SUBJECT: **DESIGN-BUILD SERVICES RFP FOR NEW FIRE STATION NO. 63**

BID # **CDB-0620-19** OPEN DATE: **2019-09-11**

SUBJECT: CDB-0620-19 – RFP Design/Build Services for New Fire Station No. 63
Acon Construction Co., Inc. Amendment 4 PO 600199-20-021

CHANGE ORDER NO 4

PRELIMINARY SKETCH FOR ESTIMATE

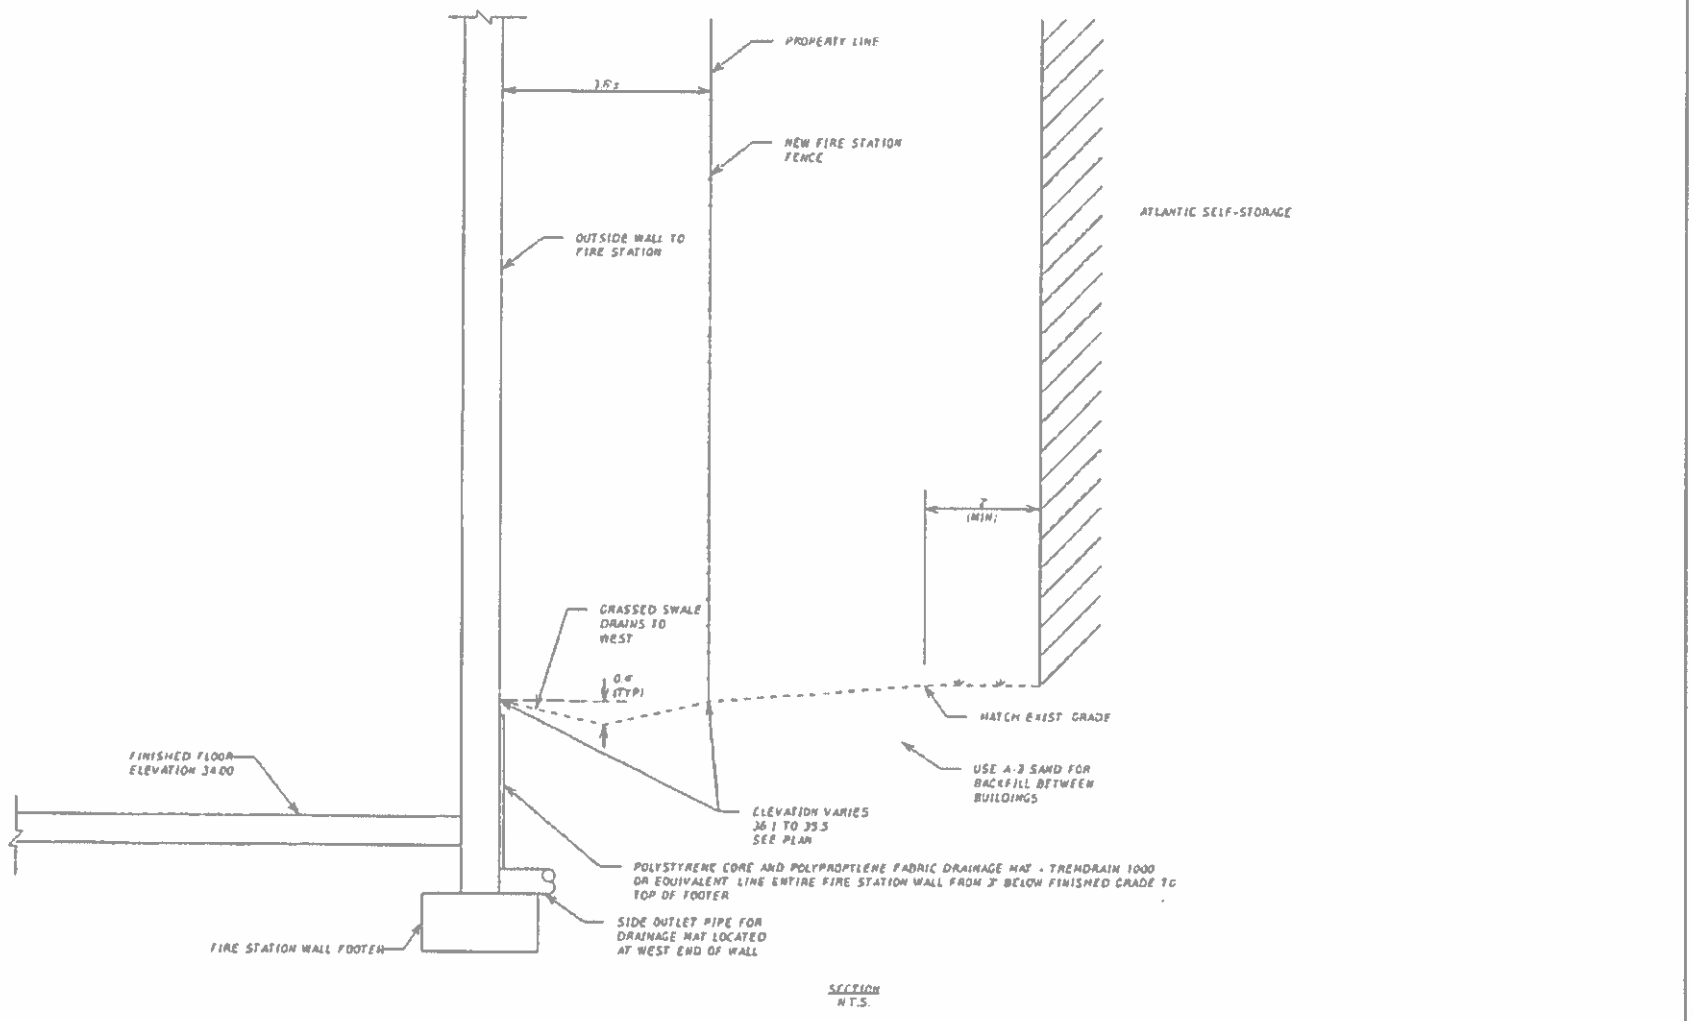
JUSTIFICATION: PCO 4 - The existing self-storage facility adjacent to the FS63 project was constructed at a considerably higher elevation than the Fire Station elevation dictated in the FS63 Design Criteria Package. This elevation difference has impacted the stormwater drainage flow on the Fire Station's southern property line. In order to handle the runoff in this area, a plan revision was requested to prevent future wash-outs and drainage issues to the Fire Station. This plan revision includes a specialty waterproofing system on the Fire Station's southern wall, as well as two wing walls and additional fill in between the existing self storage facility and fire station. PCO No. 4 also includes additional tile on the restroom walls not included in the original scope, as requested by JFRD. PCO No. 4 adds 60 calendar days to contract time.

The original DCP contained an approved site plan to include elevations. While the elevations do work as far as the site itself is concerned, a property next door was constructed at a considerably higher elevation than the new station. This elevation difference between the buildings has resulted in the City asking ACON for DB Resolution on the one side that would be impacted. Attached is a preliminary sketch along with the cost breakdowns. The end user also asked for additional tile at restroom walls previously scheduled for paint. That cost is also attached. These costs represent additions to the original project and those initial costs have been considered in arriving at the adder totals provided herein. Due to budget constraints, a contingency was not added to this change.

Description	Qty	Rate	Total
Fill CMU Wall on exterior to new grade by drilling holes and filling cells with grout/mortar	81'	1,800.00	1,800.00
Build two 10 foot long wing walls with footers to extend wall for waterproofing and drainage (includes stucco)	20' (5' TAN)	6,000.00	6,000.00
Dig by hand to expose footers and roof drain, then install drain board per drawings and manufacturer recommendations	60CY	4,400.00	4,400.00
Waterproof exterior wall and wing walls top of footing to top of new grade per drawings and manufacturer recommendations	405#	8,100.00	8,100.00
		3,800.00	3,800.00
		Total	$24,100.00
